MODEL	REV	CHANGE LIST	Model	CT3/5 MB BOARD	
			Page	FROM	TO
CT3/5 MB 31CT3MB0015 31CT3MB0031	1A	<p>PAGE 2 --- Enable CLK48M from clock generator for the PLL circuit of 7411, and disable the oscillator circuit of PCI7411 PLL.</p> <p>PAGE 3 --- Remove H/W shutdown circuit that supported ADM1032.</p> <p>PAGE 4 --- Use X7R type to replace Y5V type for CPU Decoupling/Bypass capacitor.</p> <p>PAGE 10 --- Add a terminal resistor R706 for -CODE_RST# to improve signal quality.</p> <p>PAGE 11 --- 1. Add a 10K pull-up resistor on MCH_SYNC# for booting. 2. Change the power plane of PCIE_WAKE# from 3VSUS to 3V_S5 to solve system can't turn off issue. 3. Change the power plane of ICH_THRM# and SCI_# from 3VSUS to +3V to reduce leakage.</p> <p>PAGE 12 --- We can also use 5VSUS to instead of 5V_S5 to save cost of MOSFET(A06402).</p> <p>PAGE 15 --- Add a level-shift circuit for EDID interface.</p> <p>PAGE 17 --- 1. Add a off-page and a EMI solution for CLK48M. 2. Remove the reserve resistors (R693~R695) of parallel interface for PCI1510.</p> <p>PAGE 18 --- Remove R696, connect controller and power switch directly .</p> <p>PAGE 19 --- Change R682&amp;R683 value from 56 ohms to 0 ohm cause of BOM err

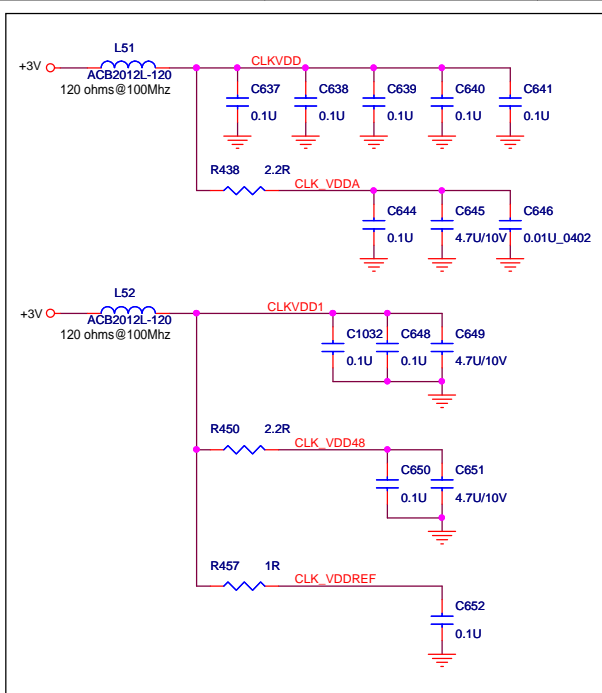
SI stage:  
Enable CLK48M from CKG. by  
R705 for the PLL circuit of 7411,  
and disable the oscillator circuit  
at PCI7411 side.

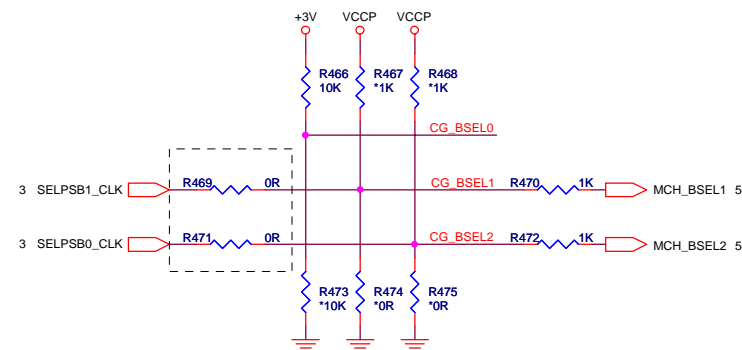
Dothan-A can remove so that the FSB frequency will be selected by  
hardware setting(R474,R475,R467,R468).  
Dothan-B should be populated.

PV stage:  
Add C1048 for CLK48M to get better EMI  
performance.

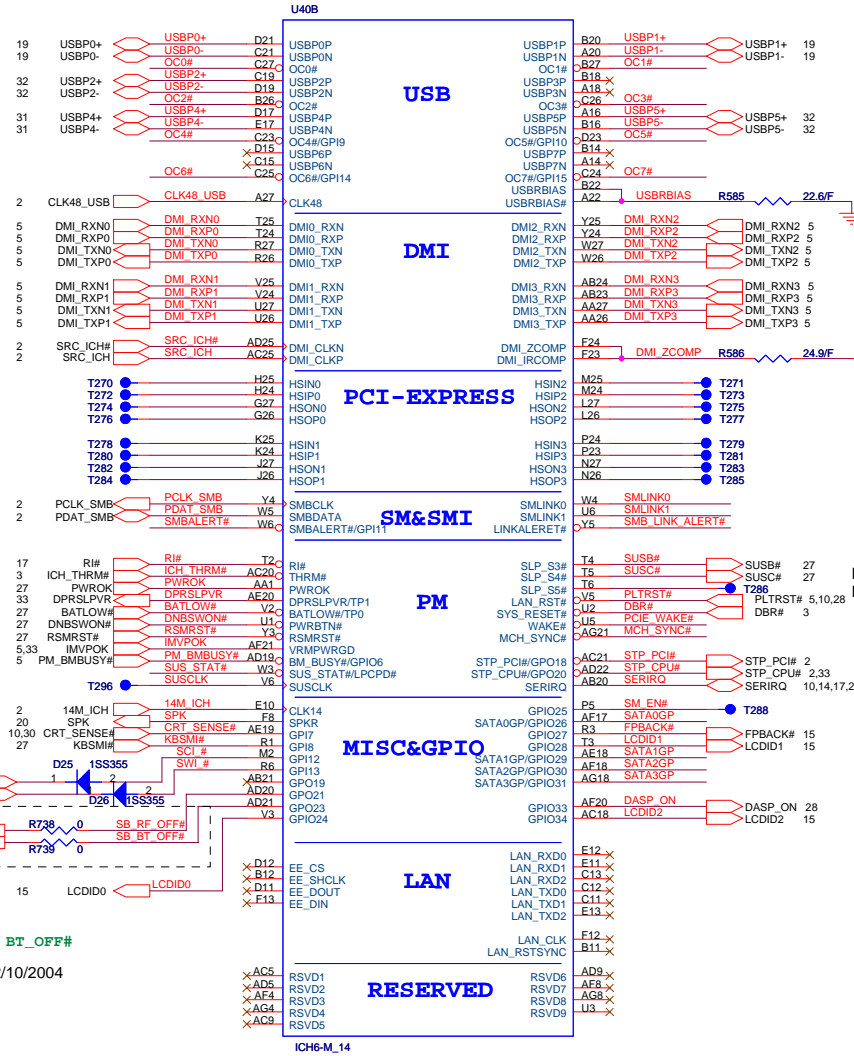
SI stage: Intel suggested us to add a terminal resistor R706 for -CODEC\_RST to improve signal quality.

PV stage: GPI40 & GPI41 for bios request.

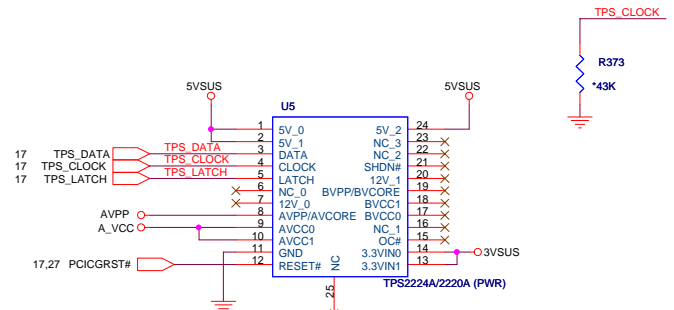
PV stage:  
Remove unused PCI1510RVGF circuit.  
Griffey 12/08/2004

## CARD POWER CONTROL

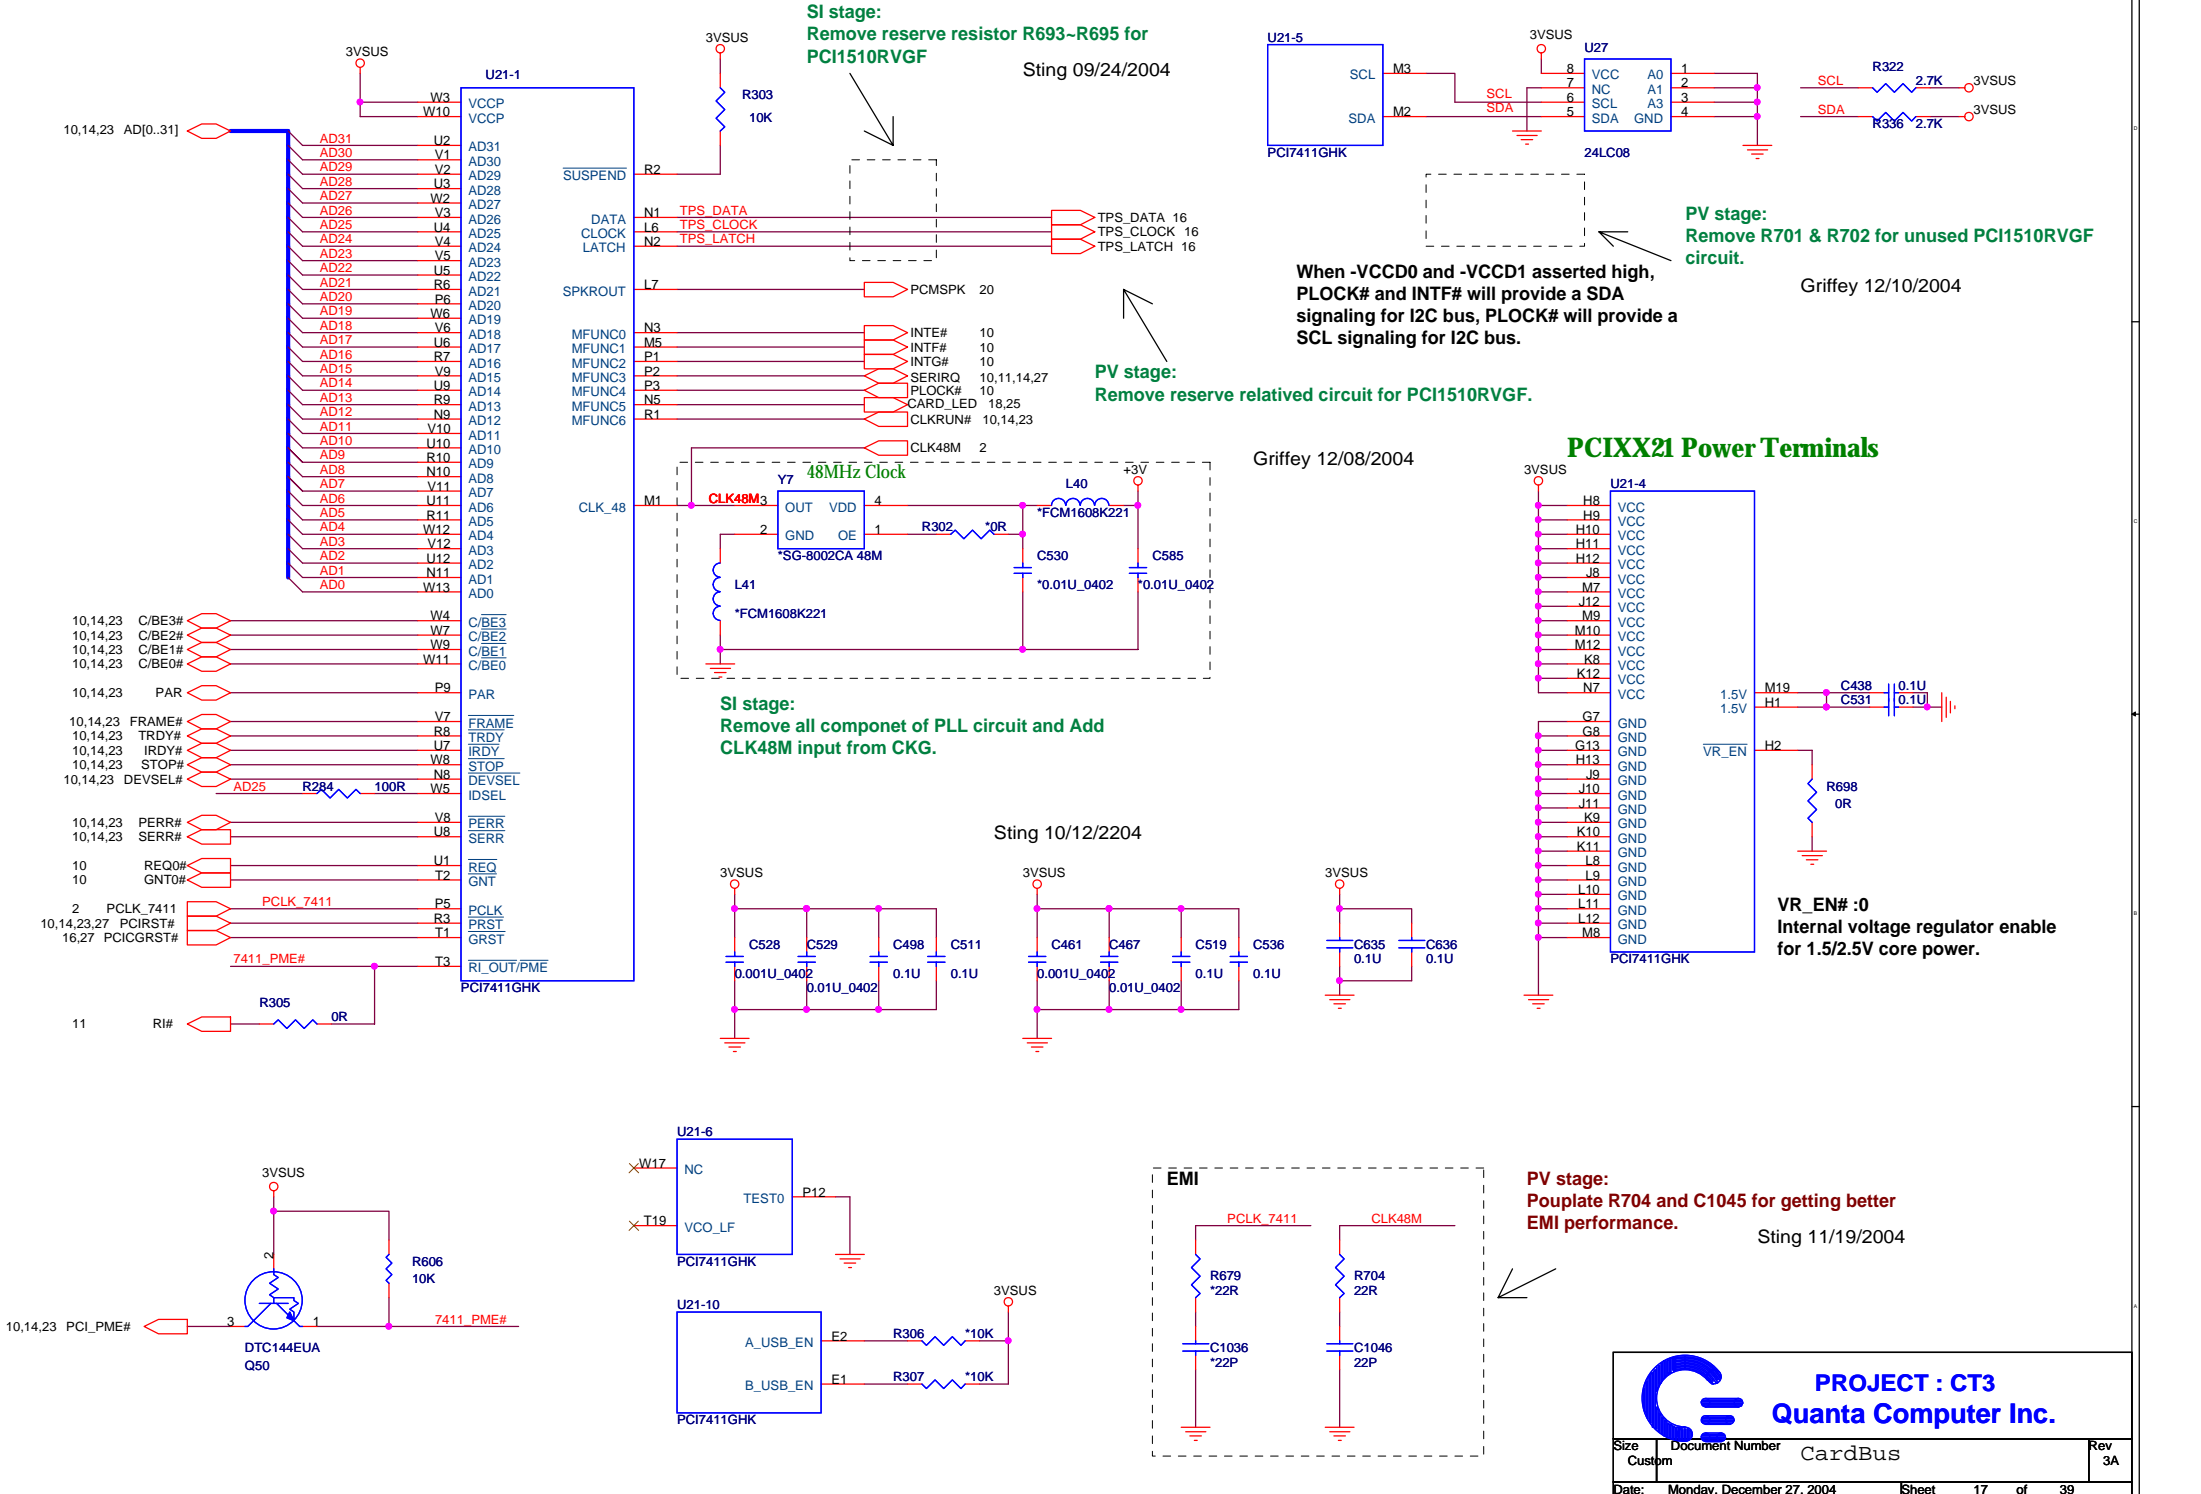
PV stage:  
Remove reserve circuit for  
PC11510RVGF.  
Griffey 12/08/2004

SI stage:  
Remove reserve resistor R696 fro  
PC11510RVGF.  
Sting 10/12/2004

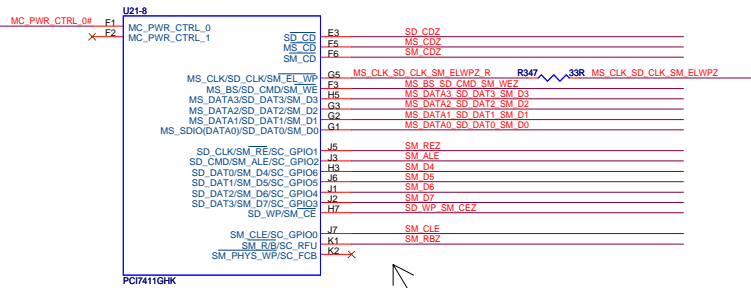
PV stage:  
Add a discharge circuit for media  
card power.  
Sting 11/19/2004

PV stage:  
1. Disconnect SM\_PHYS\_WP.  
2. Tie SM\_EL\_WP with SM\_PHYS\_WP of SM card to allow  
for normal operation of SD and SM.  
Sting 11/19/2004

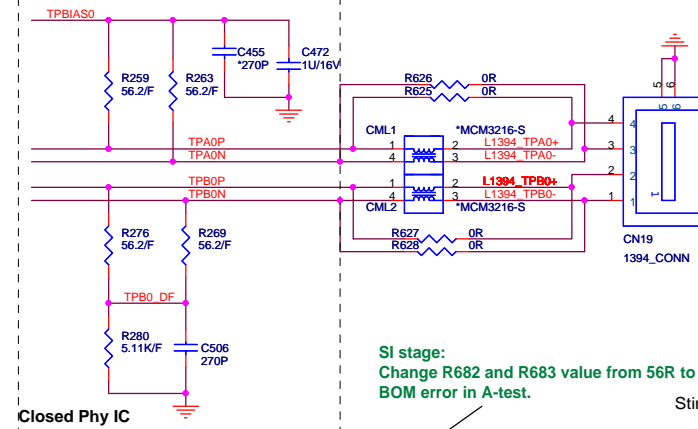
SI stage:  
Change R682 and R683 value from 56R to 0R cause of  
BOM error in A-test.

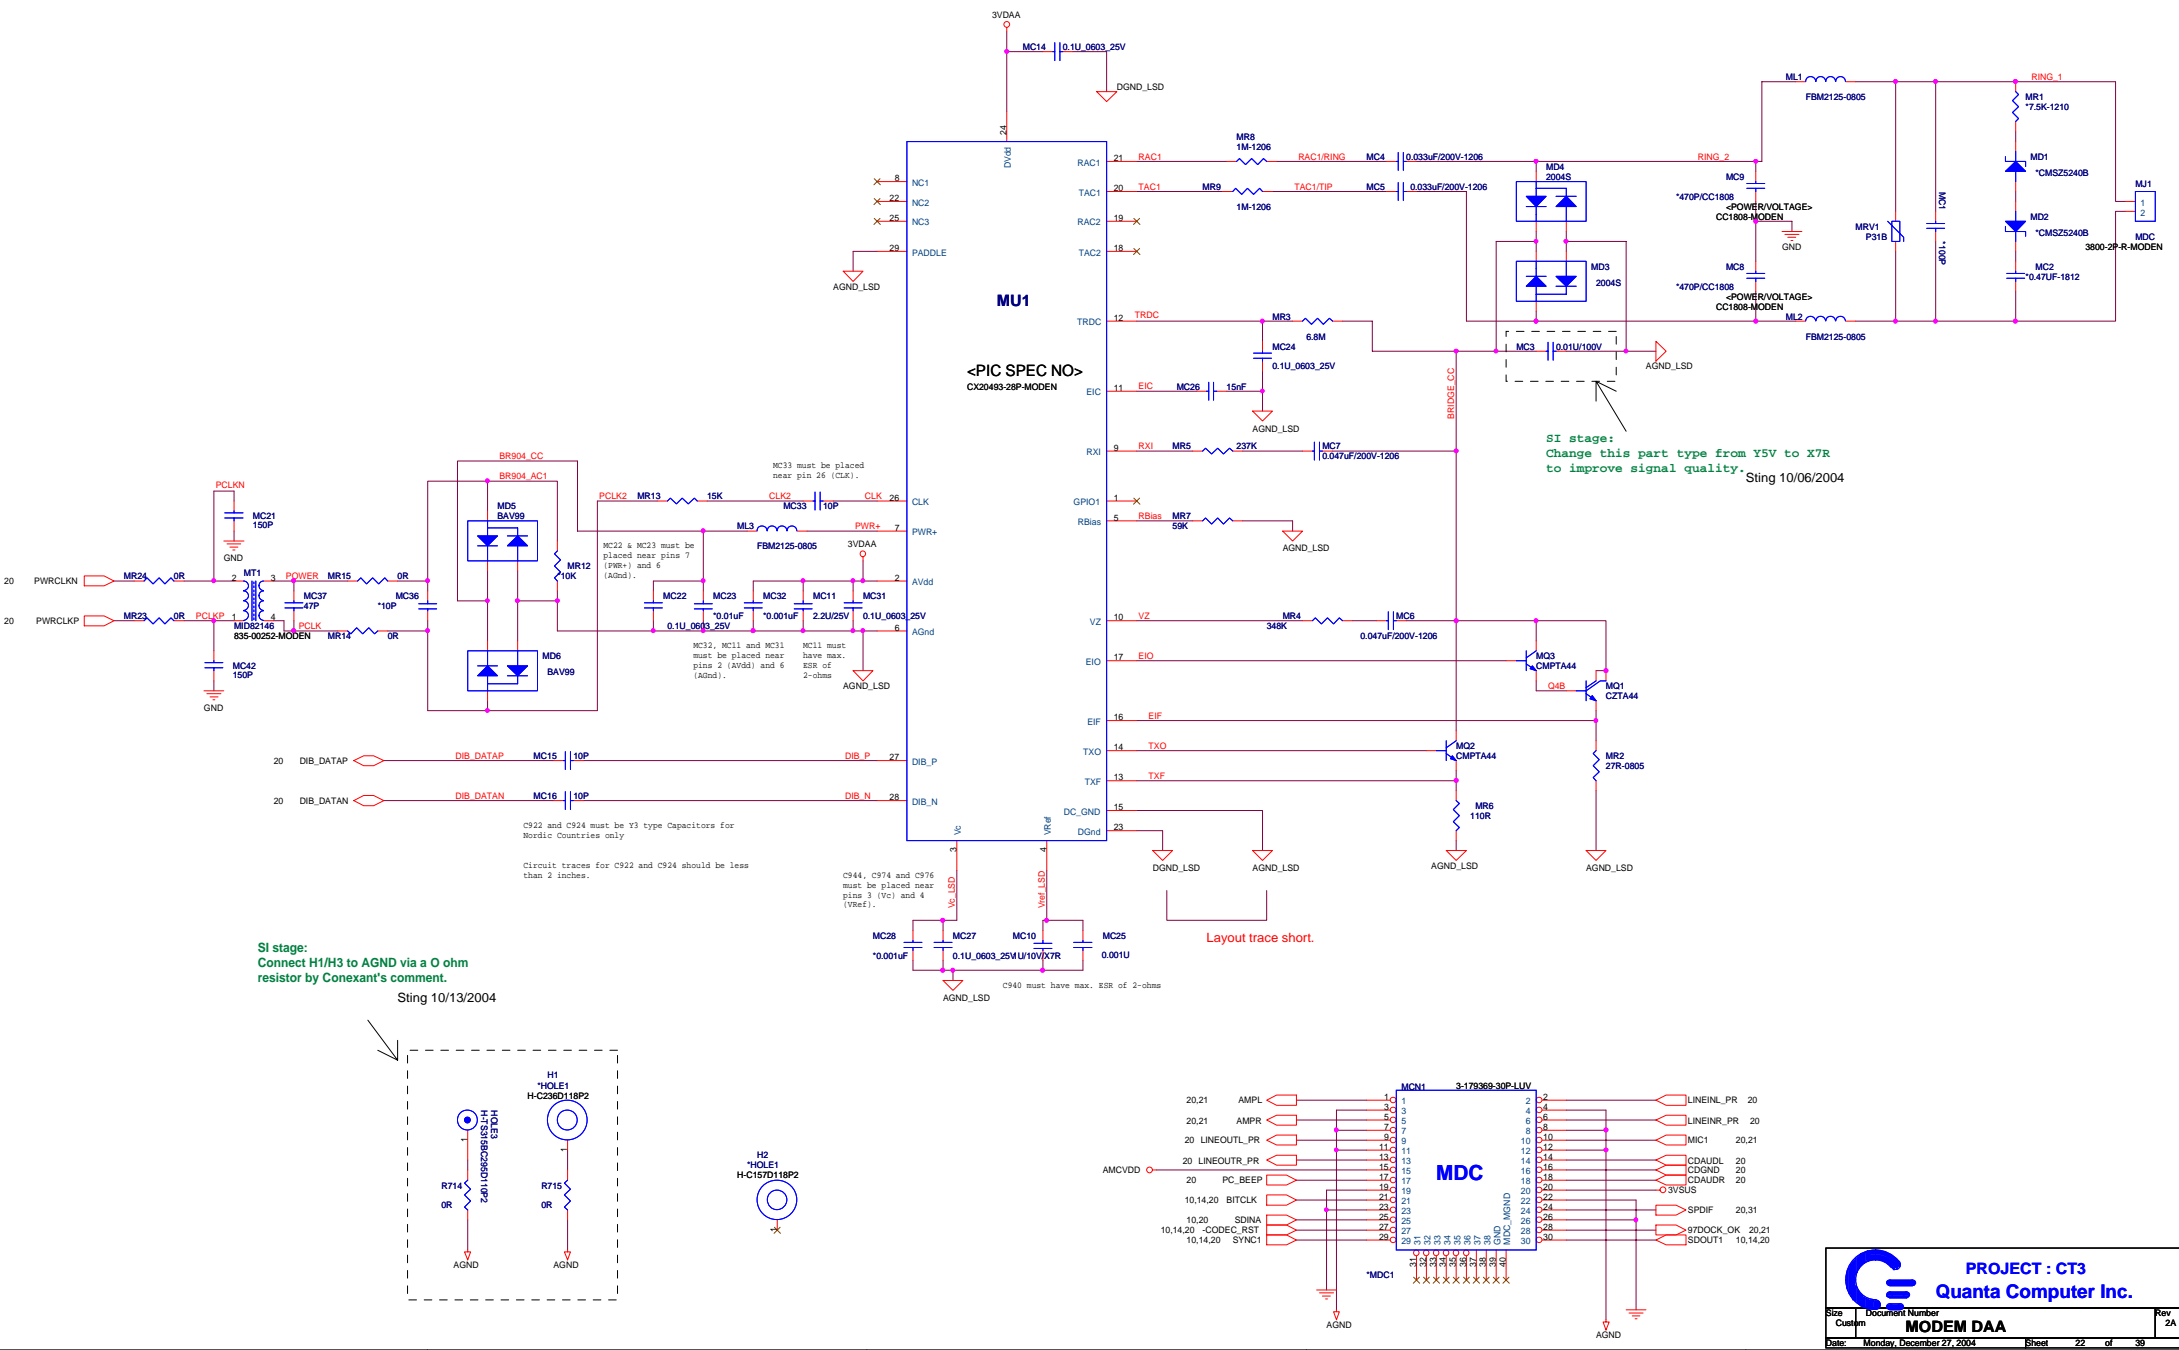
SI stage:  
Modified transformer circuit for 10/100M application.

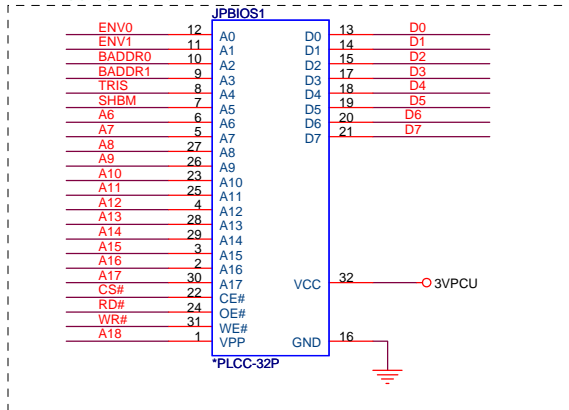
SI stage:  
Add PLCC32 cause of it is convenient for Bios debugging.  
Sting 10/01/2004

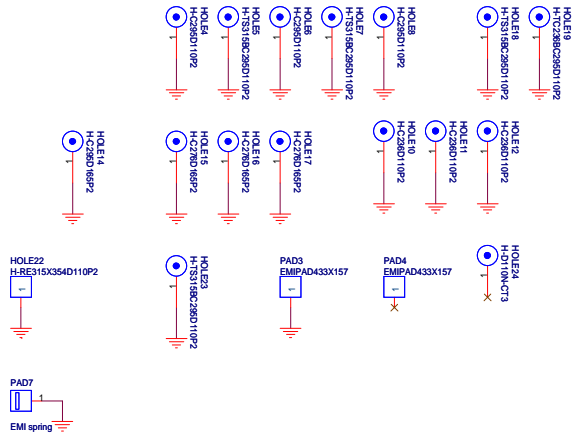
SI stage:  
Add GMT solution for B-test to costdown.  
Sting 09/24/2004

CRT PORT

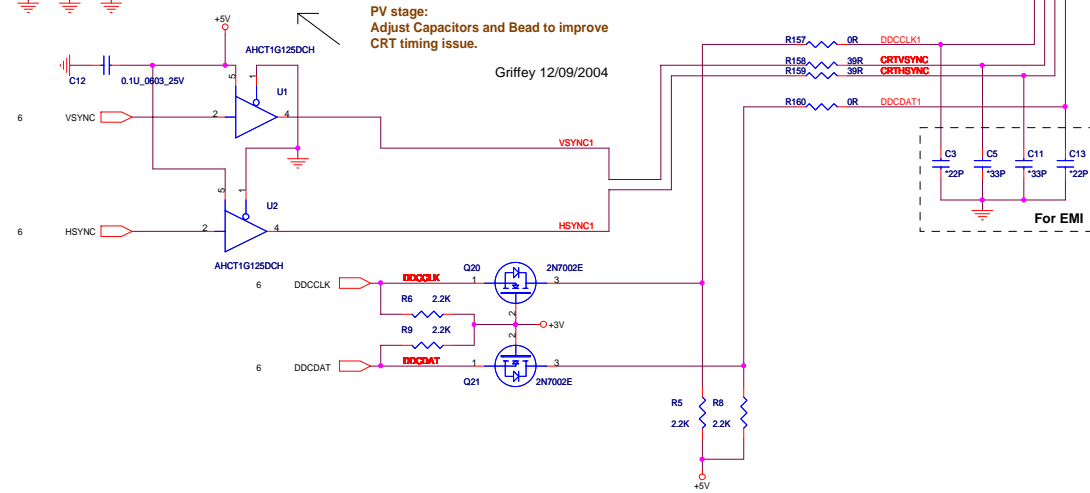
PV stage:  
Adjust Capacitors and Bead to improve  
CRT timing issue.
